MS35207F
AMENDMENT 2
29 SEPTEMBER 1999

MILITARY STANDARD

SCREW, MACHINE-PAN HEAD, CROSS-RECESSED,
CARBON STEEL, CADMIUM PLATED, UNF-2A (IN/MM)

This amendment forms a part of MS35207F, dated 21 MAY 1969, and is approved for use by all Departments and Agencies of the Department of Defense.

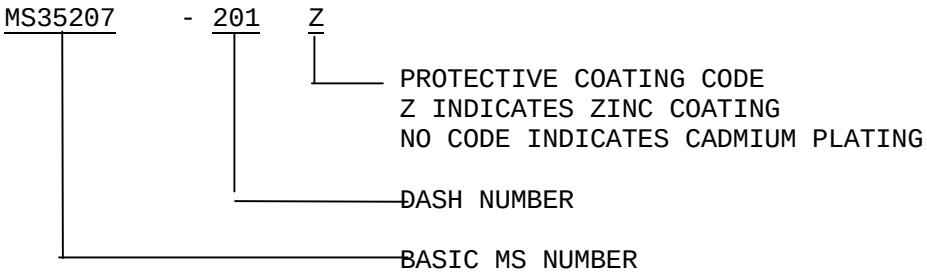
Under Part Number, add the option for Zinc Plating:

6. PART NUMBER: THE PART NUMBER SHALL CONSIST OF THE BASI MS NUMBER FOLLOWED BY A DASH NUMBER FROM TABLE I, FOLLOWED BY A PROTECTIVE COATING CODE.

MS35207-201Z INDICATES – SCREW, MACHINE-PAN HEAD, CROSS-RECESSED,CARBON STEEL, ZINC COATED, .086-56, UNC-2A, .125 LENGTH.
